Environmental and Groundwater Issues and AGL's Hunter Coal Seam Gas Project

Final Report to Hunter Valley Protection Alliance

Dr Gavin M. Mudd

February 2010

Figure 2: Conceptual model of the aquifers and groundwater resources in the Broke (adapted from PB, 2009)

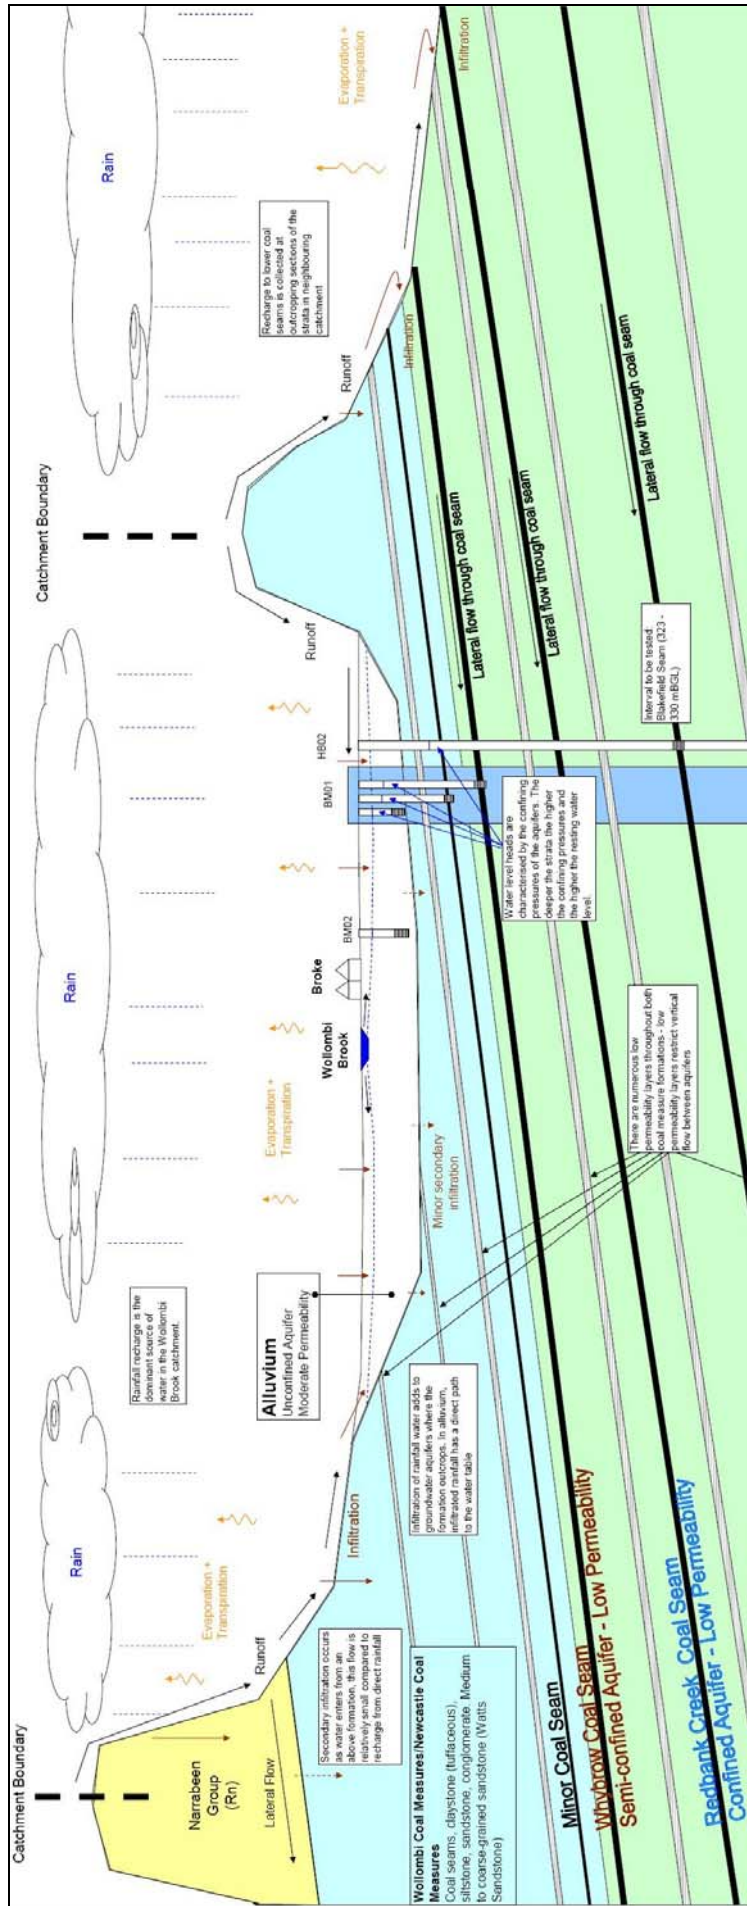
This conceptual representation of groundwater behaviour in the Broke area is fairly typical, and would be based on bore logs (showing different soil and rock types at different depths), experience from mining projects, water resources studies, monitoring data and theoretical considerations of groundwater flow in such rocks (eg. coal seams, alluvium). The movement of water between different parts of the environment, such as from runoff to soil infiltration and hence groundwater recharge, is often difficult to measure and monitor accurately. This leads to the necessity of making several assumptions about the systems' behaviour – the only remedy being long-term monitoring data. As new information becomes available, this conceptual model of the groundwater system can be updated and refined, but only if good data is continually obtained and used to inform the conceptual model.

- the frequency of monitoring is poor with respect to key and groundwater recharge processes (as shown in Figure 2), such as alluvial floods or climatic variability (eg. wet/dry conditions). For example, if the groundwater level increases or decreases in a given bore, is that due to recharge (increase), mine depressurisation (decrease) or dryer climatic conditions (decrease) ? Monitoring needs to be **at least monthly** on key bores to ensure a sufficient quality of data matching assumed groundwater flow, climatic or other processes (especially recharge rates);

Figure 5: Groundwater levels during the HB02 October 2009 pumping test, including an inset location map (adapted from Ross, 2009)

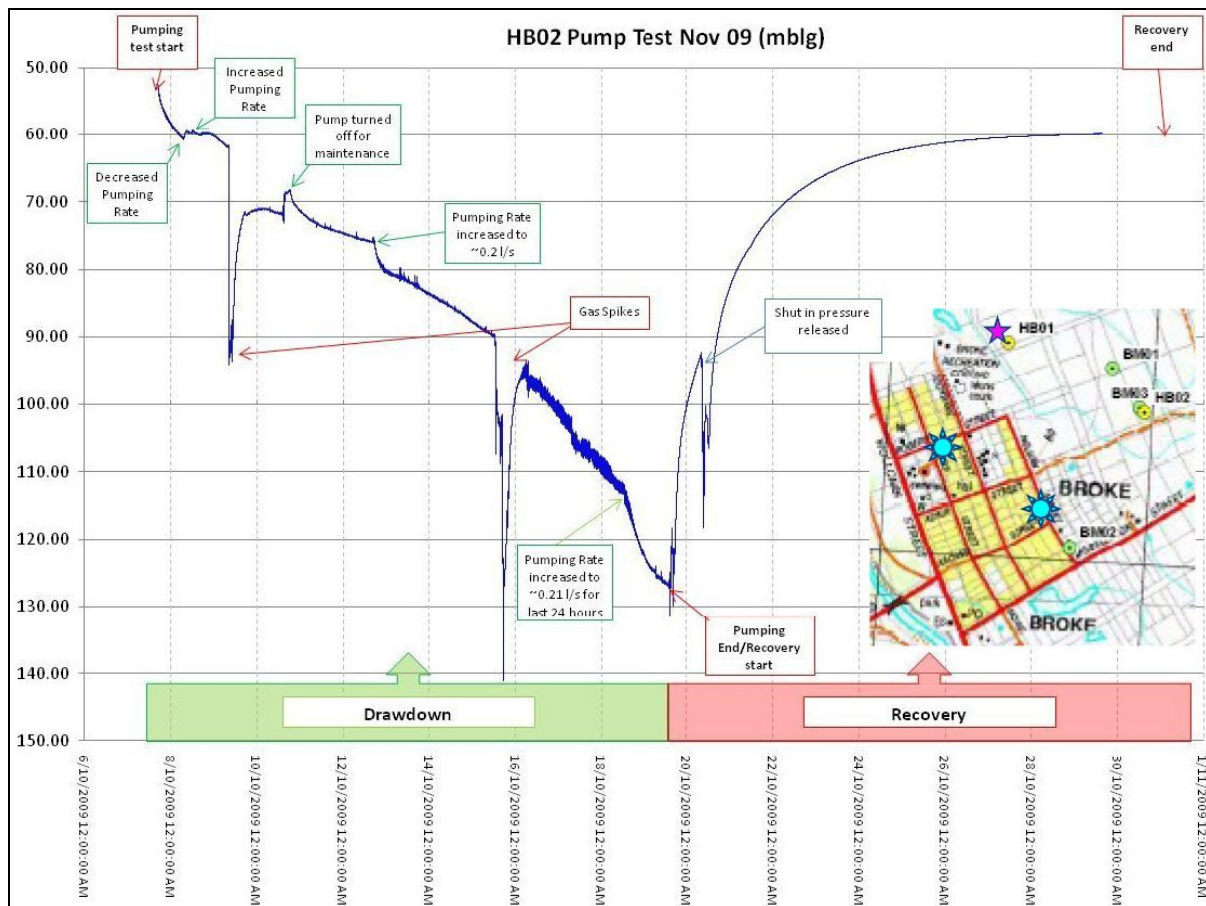
All groundwater levels are presented from the 'Top of Collar' (ToC), which is the top of the bore casing as it sticks out of the ground. Ideally, all results should be converted to relative levels, such as elevations with respect to the Australian Height Datum (AHD) – giving a precise view of the relative groundwater levels of each aquifer or layer independent of the height of each bore collar above ground. The results therefore need to be viewed carefully (especially since pumping bore groundwater levels are metres below ground; the different should be small but it still needs to be accounted for). However, the results do suggest that at present, the groundwater levels in the alluvial aquifers associated with the Wollombi Brook are slightly higher (~1 m) than those in underlying aquifers and seams. The dry period in the latter months of 2009 was arguably beginning to have an effect on alluvial groundwater levels, since they were declining slightly by September.

The difference in groundwater levels suggests a minimal hydraulic gradient (ie. pressure difference) between the shallow and deeper aquifers, with a downward direction. This needs to be considered not just in a one-dimensional view of results at BM01, but with respect to the three-dimensional nature of the geology and hydrogeology. That is, it is important to understand the sources of groundwater levels – what are the locations and geologic features that control these pressures? Is it mostly a reflection of very low permeability barriers between shallow and deep aquifers? Or is this apparent downward gradient a result of the existing impacts from longwall mining which has led to minor head declines in deeper groundwater? It is not possible, on the extent of evidence available so far, to extrapolate the finding of a minimal hydraulic gradient without significant uncertainty. That is, although it is suggestive of minimal vertical groundwater flow, groundwater behaviour needs to be further investigated, understood and assessed in its full three-dimensional characteristics.

Figure 6: Groundwater levels in monitoring bore BM01 during the HB02 October 2009 pumping test (adapted from Ross, 2009)

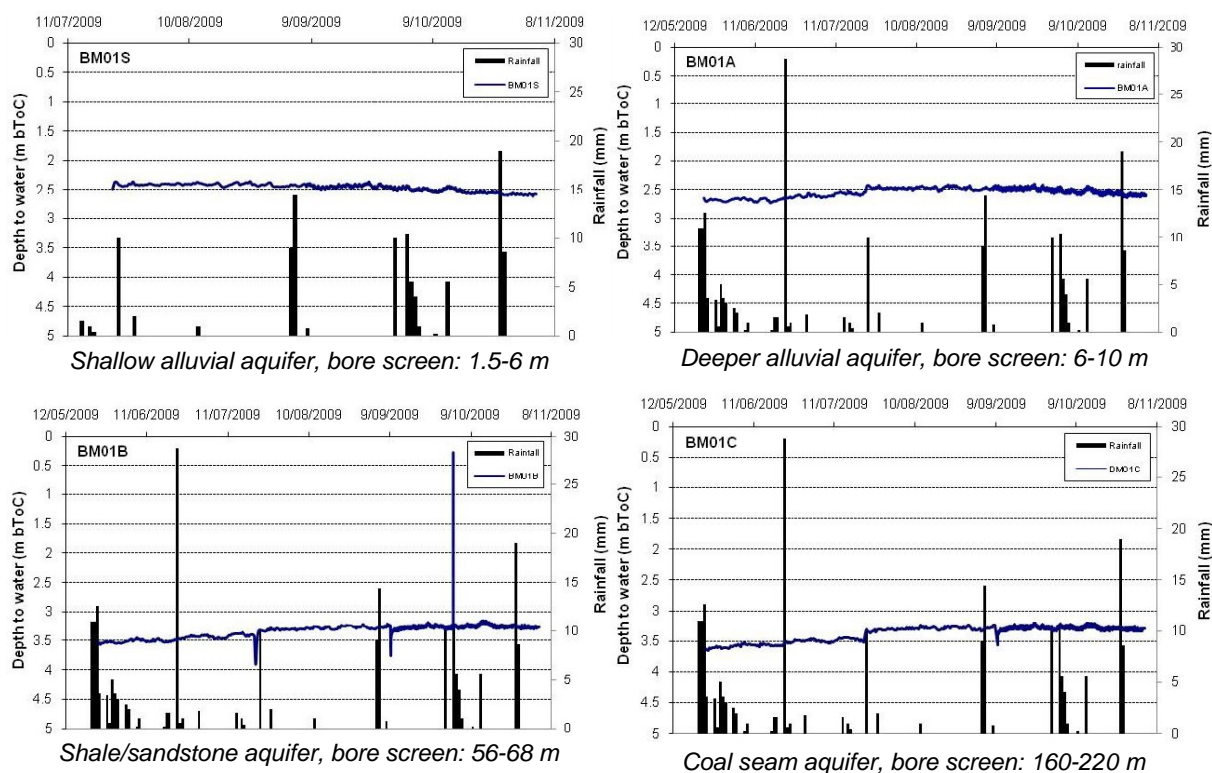
The remaining question is the degree to which the pumping test can be considered representative of any future extraction scenario. A major issue with any such extrapolation is that the test was only a single bore – compared to potential production scenarios which would require numerous bores. Further comment can be provided once the PB report is completed.
